2.0 SITE CHARACTERISTICS

This chapter of the North Anna 3 Combined License (COL) Final Safety Analysis Report (FSAR) addresses the geological, seismological, hydrological, and meteorological characteristics of the site and vicinity, in conjunction with present and projected population distributions and land use and site activities and controls.

The site characteristics are reviewed by the U.S. Nuclear Regulatory Commission (NRC) staff to determine whether the applicant has accurately described the site characteristics and site parameters together with site-related design parameters and design characteristics in accordance with Title 10 of the *Code of Federal Regulations* (10 CFR) Part 52, "Licenses, certifications, and approvals for nuclear power plants." The review is focused on the site characteristics and site-related design characteristics needed to enable the staff to reach a safety conclusion on the siting of North Anna 3. The North Anna 3 combined license application (COLA) references the Economic Simplified Boiling-Water Reactor (ESBWR) Design Control Document (DCD) as well as the North Anna 3 early site permit (ESP-003). For a COL application referencing a design certif

Figure 2.5.2-7. Map of Changes in Seismicity Rates and B-Values for CEUS-SSC Source Zone ECC-AM, Case A (Figure from Applicant Response to RAI 2.5.2-7.)

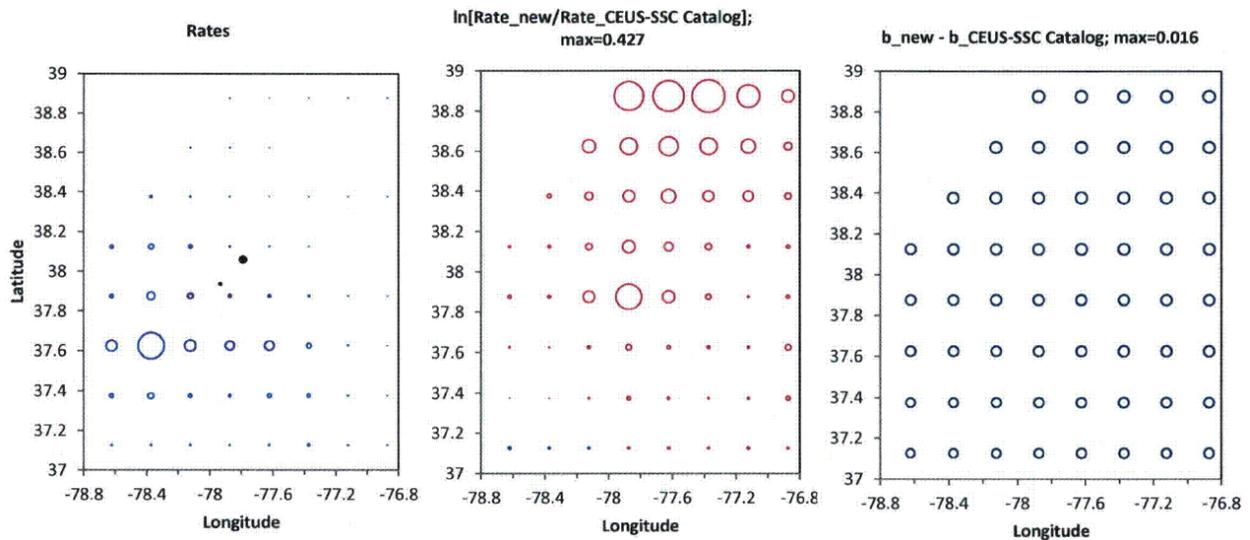
In the response to RAI 2.5.2-7, dated May 9, 2014 (ADAMS Accession No. ML14140A087), and supplemented on May 29, 2014 (ADAMS Accession No. ML14150A439), the applicant provided detailed information about how the updated seismicity catalog influenced rates and b-values in the CEUS-SSC and provided the requested comparison of hazard. The applicant provided plots (example shown on Figure 2.5.2-7 of this SER) of updated rates and b-values for the four distributed seismicity zones that the North Anna 3 site lays within (ECC-AM, MESE-N, MESE-W, and STUDY-R). The applicant also provided tables of the updated seismic hazard at a variety of input spectral acceleration levels. The applicant demonstrated that the updated seismic catalog increases hazard at the North Anna 3 site up to 27 percent for annual frequencies of exceedance lower than 10^{-3} .

The staff reviewed information provided by the applicant in response to RAIs about the CEUS-SSC catalog updates and the Mineral earthquake. The staff conducted a site audit on May 8, 2014, as documented in ADAMS Accession No. ML14203A179, during which the staff and the applicant discussed the details of their approach to the catalog updates and site response.

Figure 2.5.2-8. Comparison of the Applicant's Base Rock Hazard Curves with the Results of the Staff's Confirmatory Analysis

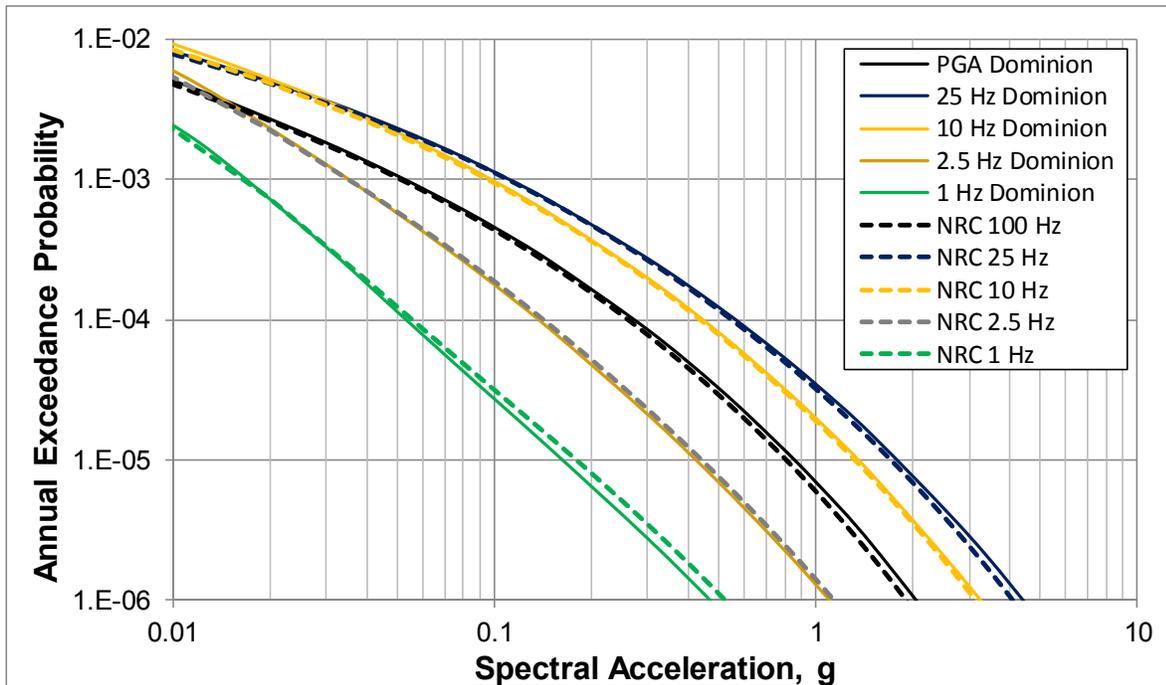
The staff also conducted an independent confirmatory analysis of the PSHA. The staff calculated the hazard at the North Anna 3 site using the published CEUS-SSC for distances up to 500 km (310 mi) for distributed seismicity sources and 1,000 km (620 mi) for RLME sources. In its confirmatory analysis, staff used the EPRI (2013) GMM. Figure 2.5.2-8 of this SER compares the PSHA results from the staff's independent confirmatory analysis with those of the applicant for PGA and frequencies of 25, 10, 2.5, and 1 Hz. The staff's and the applicant's calculations are in good agreement. The staff used its independent PSHA results to develop site specific UHRS at the 10^{-4} and 10^{-5} exceedance frequencies. SER Figure 2.5.2-9 compares 10^{-4} and 10^{-5} UHRS developed by the staff with those developed by the applicant. Because the UHRS results developed by the staff are in good agreement with those developed by the applicant and the applicant has incorporated seismicity after the publication of the CEUS-SSC, including the Mineral earthquake, the staff finds the applicant's PSHA acceptable.

Based on the applicant's response, the results of staff's site audit and its independent confirmatory analysis, staff considers RAI 2.5.2-7 resolved and closed.

Figure 2.5.2-11. Comparison of the Applicant's GMRS with the Results of Staff's Confirmatory Analysis at Elevation 68.3 m (224 ft.).

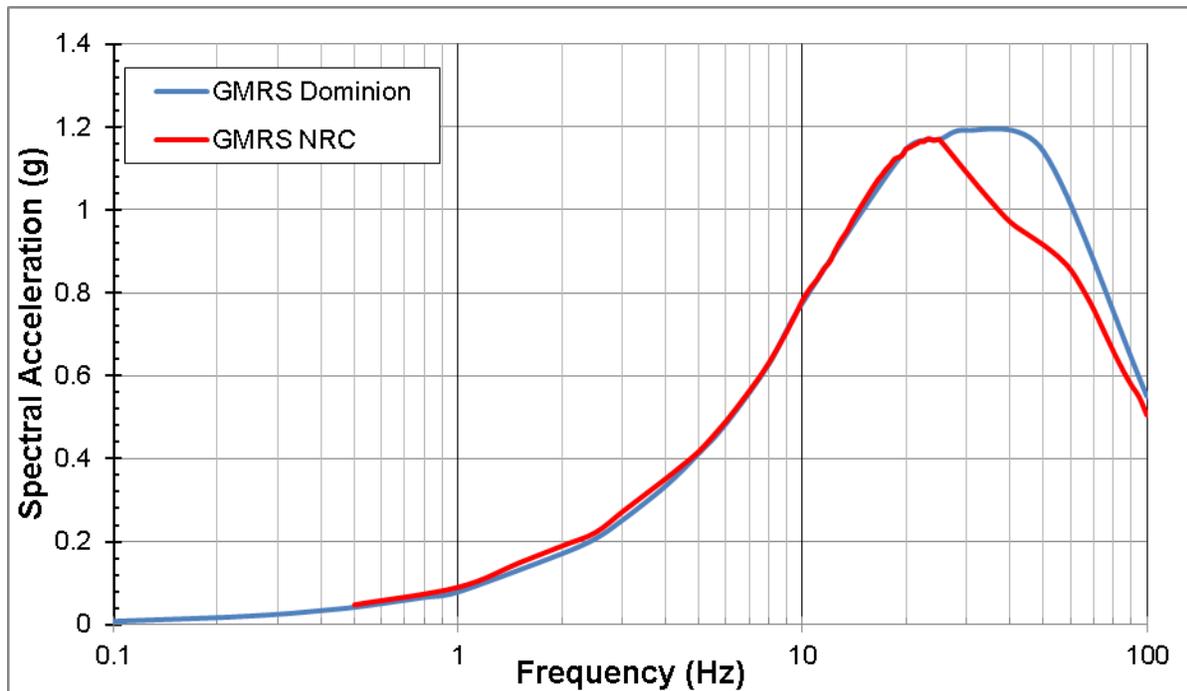
The staff performed a confirmatory analysis of site response using values reported by the applicant for geophysical parameters. The staff independently developed best estimate velocity profiles, randomized the velocity profile and shear modulus degradation and damping curves and calculated site specific amplification functions at the GMRS elevation. Figure 2.5.2-10 shows a comparison of amplification functions developed by the staff with those developed by the applicant. The differences in site amplification functions calculated by the staff and the applicant are not significant considering that staff used Approach 3 and the applicant used Approach 2, as described in NUREG/CR-6728, for the site response calculations. The staff subsequently combined its PSHA results at the 10^{-4} and 10^{-5} exceedance frequencies with its amplification functions and calculated a site specific GMRS. Figure 2.5.2-11 shows a comparison of the site

Based on the applicant's response to RAIs related to the site response calculations and staff's independent confirmatory analysis that is consistent with the applicant's results, the staff considers RAI 2.5.2-2; RAI 2.5.2-3; and RAI 2.5.2-6 resolved and closed.
